ORIGINATION FORM

Proposed Revisions to a Standard Plans Index
(Please provide all information — Incomplete forms will be returned)

Index Number: 509-100
Sheet Number (s): 1 of 1
Index Title: Advance Warning For R/R Crossing

Sheet 1: Changed "Class I" to "Class II" in the Front View of the ACTIVE STATE Detail.

ACTIVE STATE
(TRAIN CIRCUIT ACTUATED)

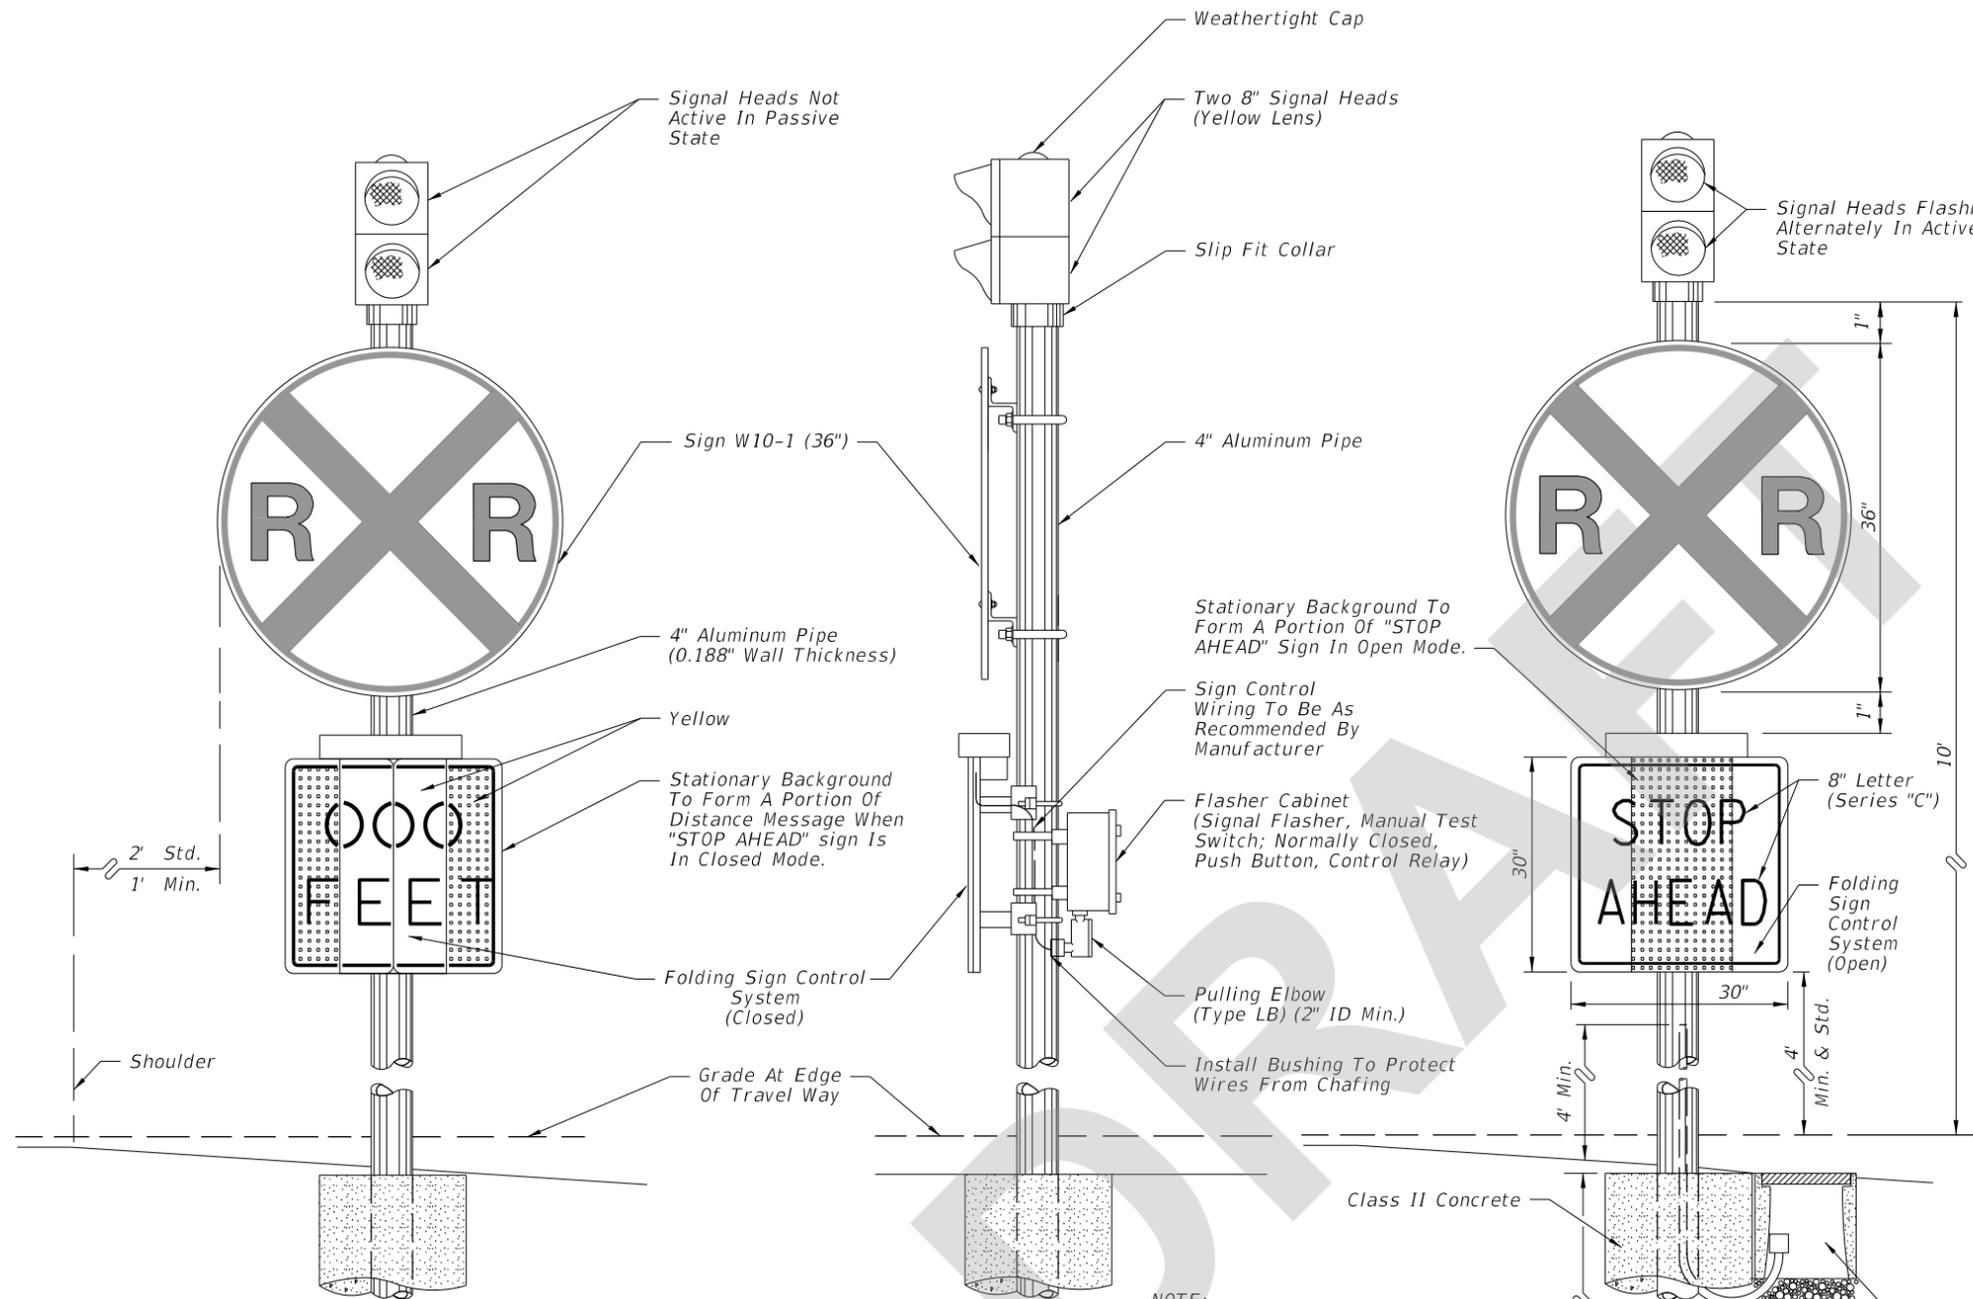
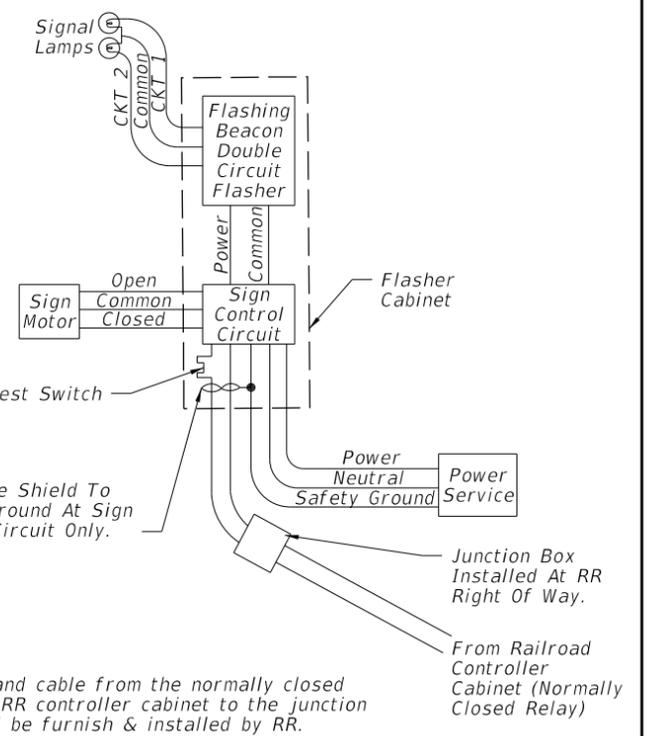
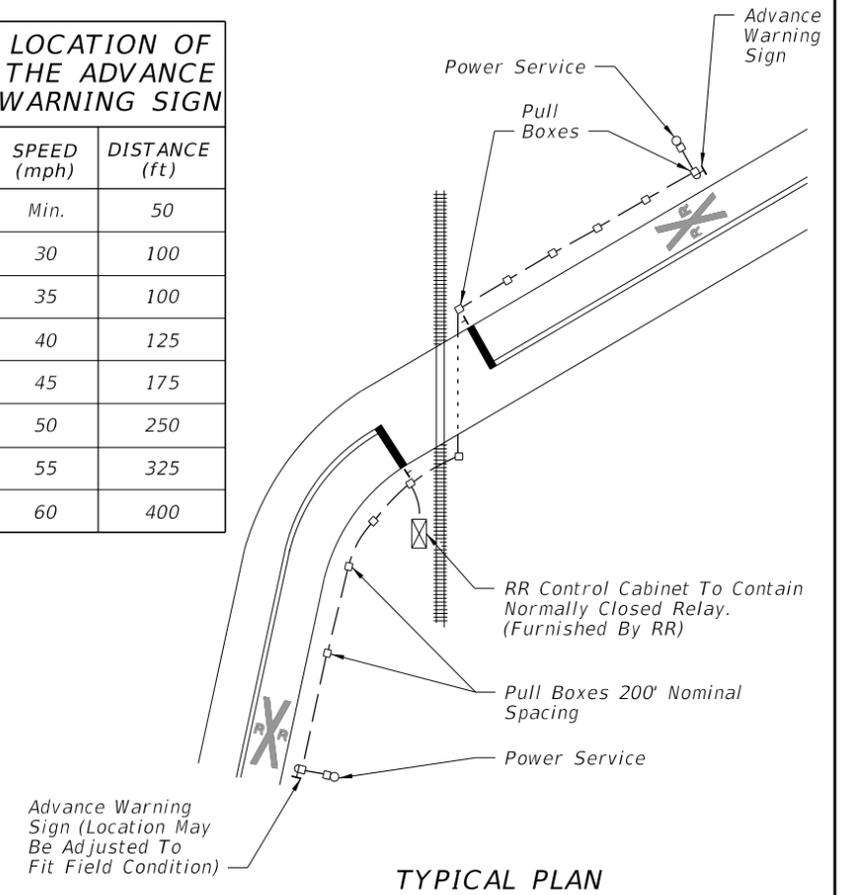
CHANGED TO: Class II

Changed to reflect Materials specification change that removes the designation for Class I Concrete.
Please see the attached Standard Specification Section 346 DRAFT for the Class I revisions proposed by the State Materials Office.
